| ITEM | PAGE |
|--|-------------|
| 8.13 Waimea Community Dam Project Status Report RCN16-09-20 | |

Waimea Community Dam: Peer Review of Waimea Plains Hydrology

**Waimea Community Dam: Peer Review of Waimea
Plains Hydrology underpinning the proposal**

Attachment to Appendix 1 – Waimea Community Dam Project Status Report

Figure 1: Total groundwater flow in the period of November and April in the Waimea Plains (reproduced from Fig. 11 of GNS, 2003)

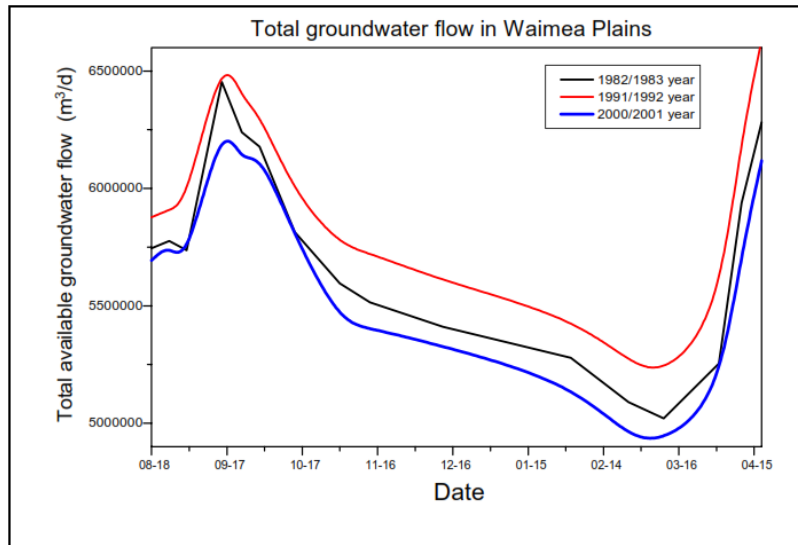
The errors noted relate to the units used in Figure 11 of GNS (2003) (reproduced below in Figure 1) and Table 8, where the groundwater through-flow is over-reported by a factor of 7 because weekly (m^3/week) rather than daily (m^3/day) data have been plotted, and these data are also described too loosely as 'available groundwater flow' when this water is not all 'available' for extraction. These are reporting errors rather than a modelling error and have not affected any of the conclusions reached by GNS in that report.

A: We have contacted GNS Science about correcting the reporting errors in their 2003 report. These changes can apparently be made and the revised report made available on-line. The errors are drafting errors rather than modelling errors of consequence for decision-making.

Figure 4: Modelled versus measured Wairoa River losses: low flows

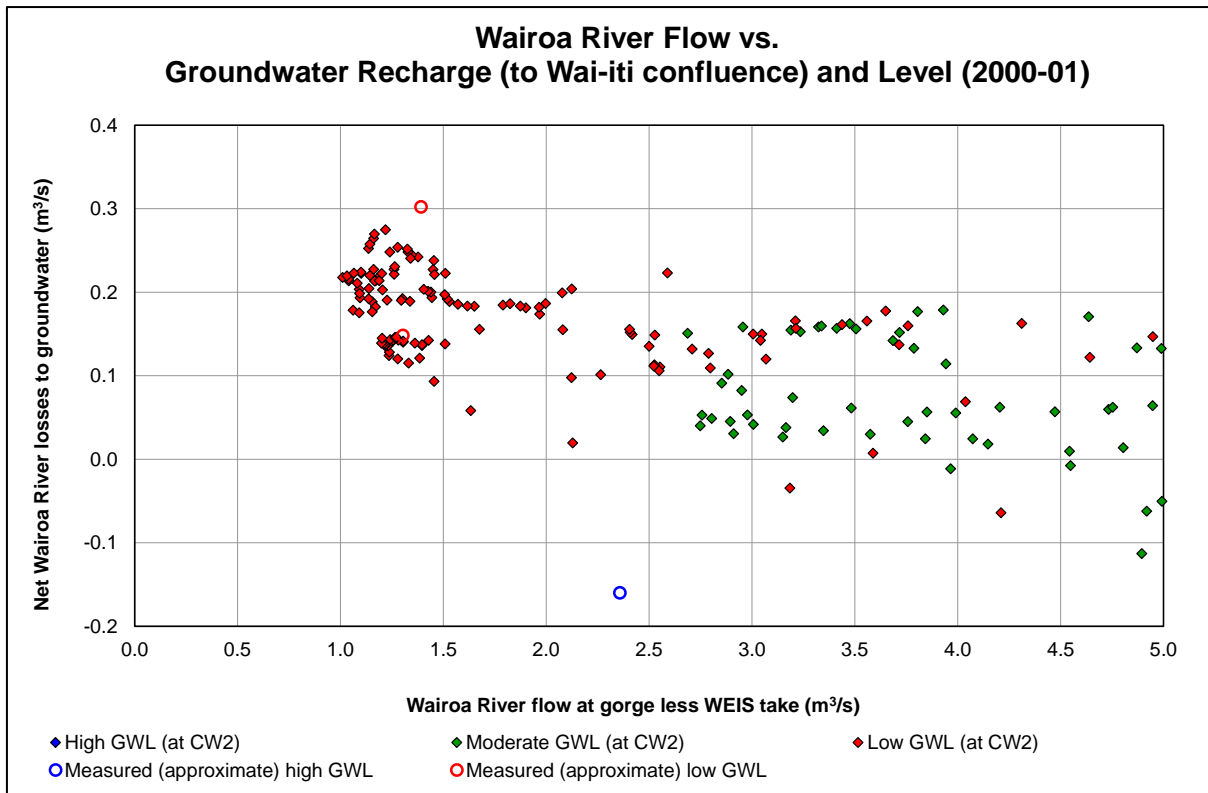
The model's ability to replicate measured flow losses is presented in Figure 4 for the 2000/01 model period. Here, both modelled and measured losses in the Wairoa River between the gorge and the Wai-iti confluence are plotted (allowing for WEIC takes). This is the generally losing reach of the river. To demonstrate the relationship with groundwater levels, losses are presented for periods of low, moderate and high groundwater levels based on Delta Zone well CW2 as an indicator.

Figure 4 presents this relationship for low gorge flows (up to 5 m³/s²). Though it appears there is an upper limit to the river losses, at higher flows the losses are a little greater (and more variable). This is demonstrated in Figure 5. Although there are only a few measurements with which to compare, the model is consistent with the few that are available.

A: River recharge to groundwater is dynamic, highly variable, and dependent on multiple factors, including river stage height and depth to underlying groundwater. Generally, as river flows increase, so too does river recharge to groundwater. Similarly, as groundwater levels drop, river recharge to groundwater increases. Modelled response is consistent with measured.

Figure 8: Modelled Nursery river flows comparing daily stresses with hourly river flows and diurnal groundwater pumping

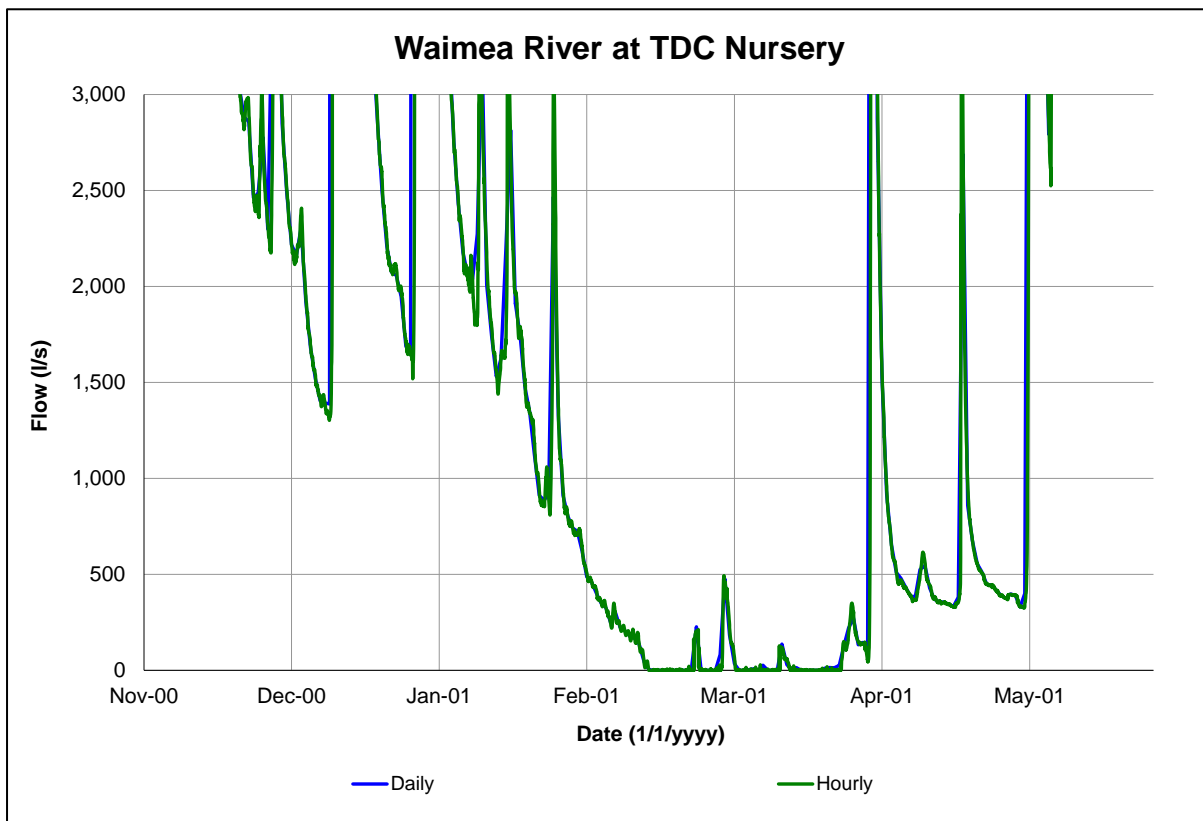
Q: Do diurnal variations in river flows and pumping affect model predictions?

Based on Figure 8, the predicted flows at TDC's Nursery site are very similar whether daily or hourly river flows are used, particularly during the low-flow periods when important management decision are being made. A few points to note:

A: Modelling sub-daily river flows does not noticeably affect the groundwater model's predictions, particularly for the extended stable, dry periods where water management is critical. No pumping data is available to test the effects of sub-daily values of groundwater abstraction, but due to the storing and buffering nature of the groundwater system, there is also likely to be an insignificant difference compared to the assumption of daily-averaged abstraction.

Figure 9: Modelled Nursery river flows comparing daily and hourly river flow stresses with diurnal groundwater and WEIC pumping

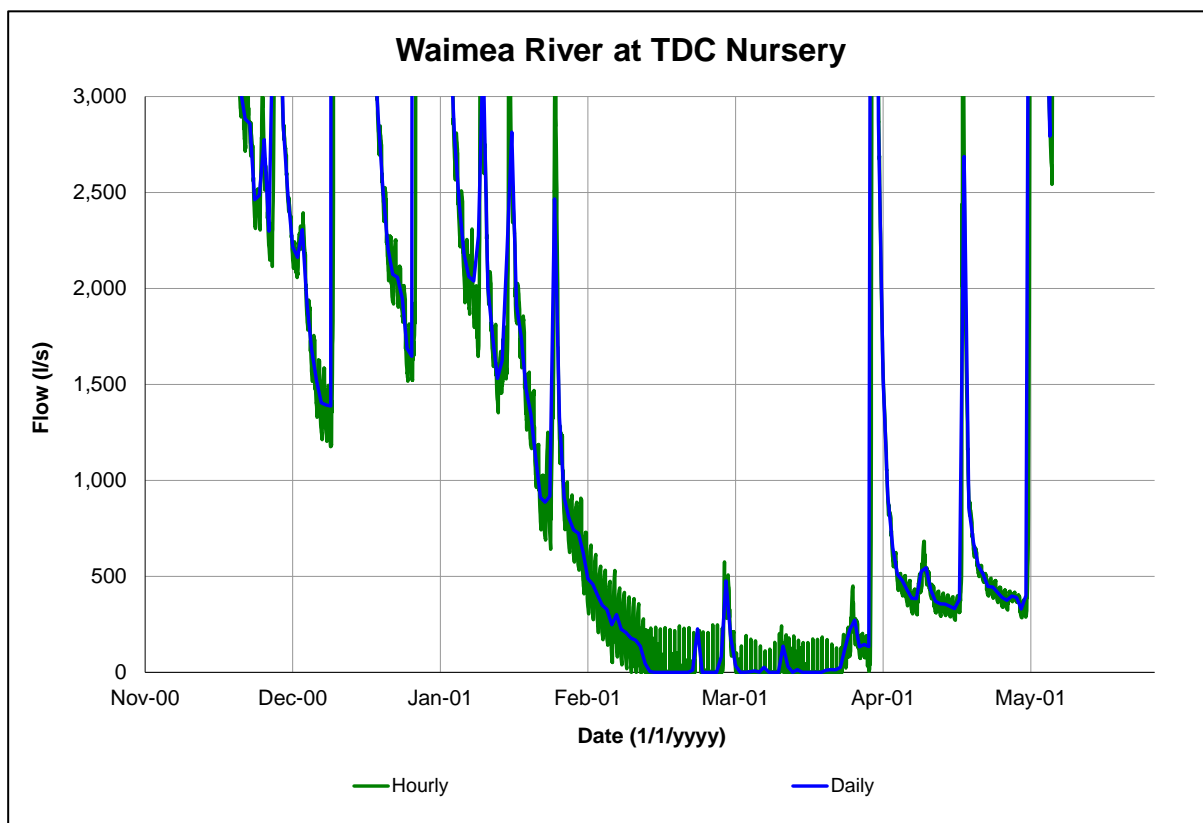
In Figure 9, the same diurnal pumping assumption has been applied to the WEIC river water take below Wairoa Gorge. The time-varying river flows propagate downstream to the Nursery site in the Waimea River. However we note that this level of river flow fluctuation is not seen in the recorded flows available at the TDC Nursery recorder site and therefore appears unrealistic.

Figure 13: Modelled Wairoa River losses comparing Calibration and Dam-Release scenarios

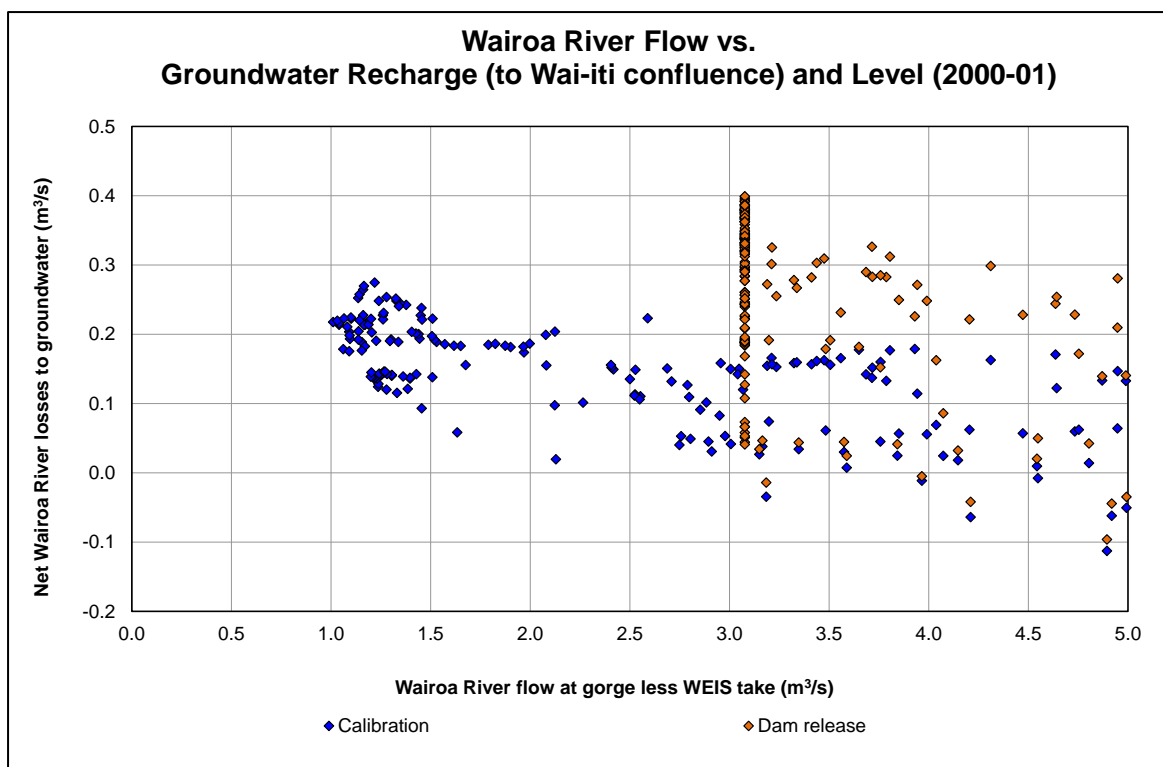
If the proposed Lee Valley dam releases additional water to maintain a minimum flow of 1,100 l/sec, the river flows will be higher and so too will groundwater recharge. This is demonstrated in Figure 13 which compares modelled Wairoa River losses under the calibration scenario (which is the same modelled data presented in Figure 4) with losses under the dam release scenario. River losses are larger while the dam releases water during low flow periods because river flows are higher. The target minimum flow of 1,100 l/sec is achieved with a minimum gorge flow of 3,077 l/sec; this is clearly visible on the plot with a range of river losses to groundwater of 40 – 400 l/sec occurring as a consequence of flow releases from dam releases. Additional groundwater pumping in the Dam-Release scenario also means that losses at other non-low-flow periods are also different.

A: The amount of water that can be infiltrated into the groundwater system is limited by the driving head between the river and groundwater and the ability of the groundwater system to receive the water. Larger river flows (as would be expected with augmented river flows) will result in increased river recharge.

Figure 15: Net river recharge for various scenarios with and without weirs

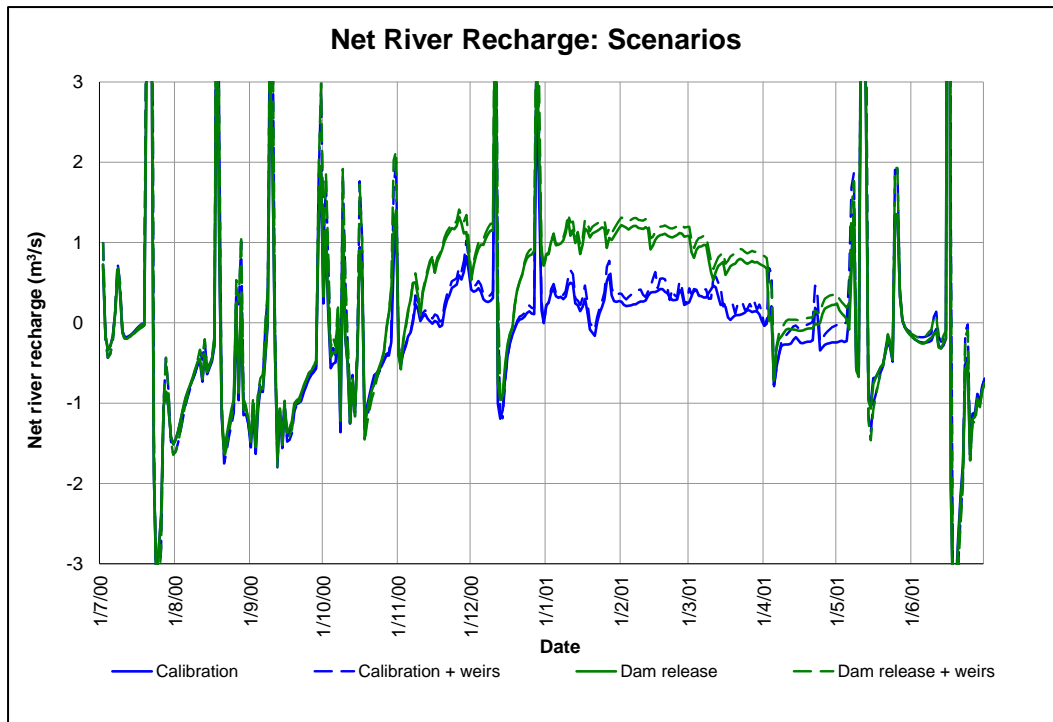
This model was then run with and without dam releases. Figure 15 presents the net river recharge (for the full model domain) for both the calibrated model and the dam-release model, comparing without weirs (the solid line) and with weirs (the dashed line). A very small increase is predicted due to the weirs, considerably less than the difference in recharge comparing 'Calibration' and 'Dam release' scenarios.

A: While weirs do increase the river recharge to groundwater other than in periods when the river is dry, their positive effect is likely to be limited to the vicinity of the weirs, and considerably less than the positive effects of augmented river flows. In addition, without augmented river flows during low flows, upstream weirs may deprive flow from downstream reaches, drying the lower river sooner.

Figure 19: Measured Wai-iti Dam releases and downstream responses

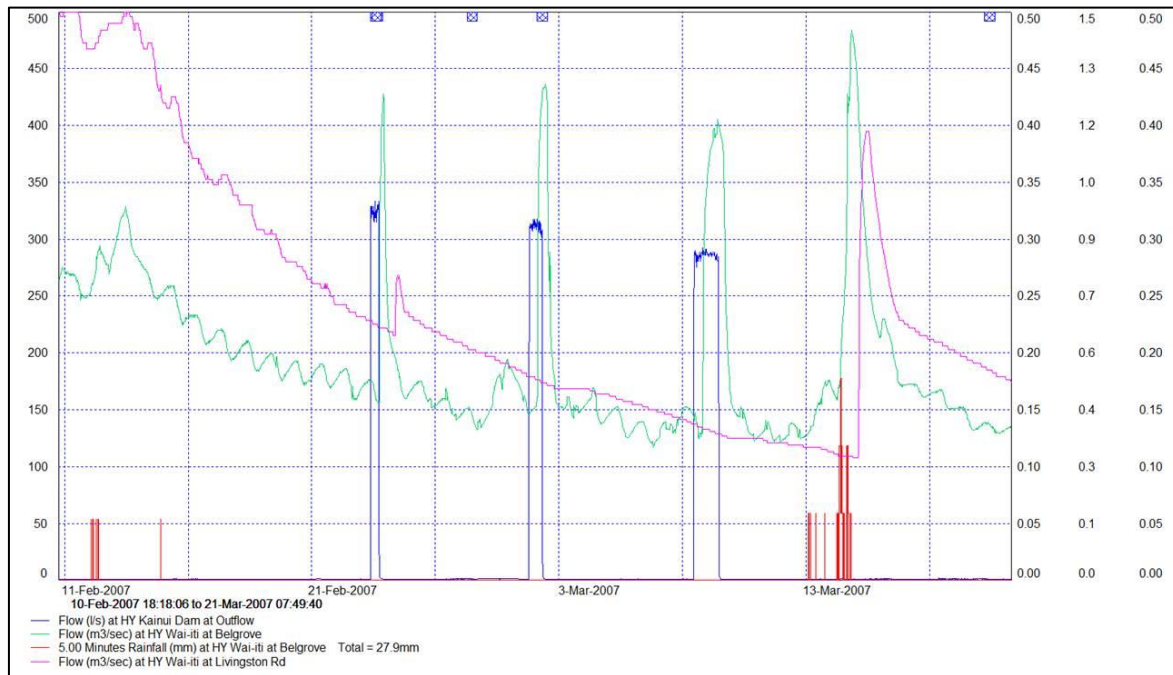
Q: Does TDC experience with Wai-iti's Kainui Dam give confidence the Lee dam will work as intended?

From Figure 19, a clear and immediate response is observed at the down-gradient Belgrove river site as the release is switched on and off. TDC staff try to maintain a flow of 100 l/sec at Livingston Road by releasing water from the dam during dry periods. When they achieve this, the river usually dries just below the bottom weir during dry periods. Prior to the dam, the river would normally go dry much further upstream of the weirs.

A: The Wai-iti dam is somewhat smaller than the proposed Lee Valley dam, and designed for a more constrained purpose (riparian supply rather than catchment augmentation). However, it is clear from the little data that is available that releases from the dam do provide obvious and rapid responses in groundwater through increased river flows and recharge.
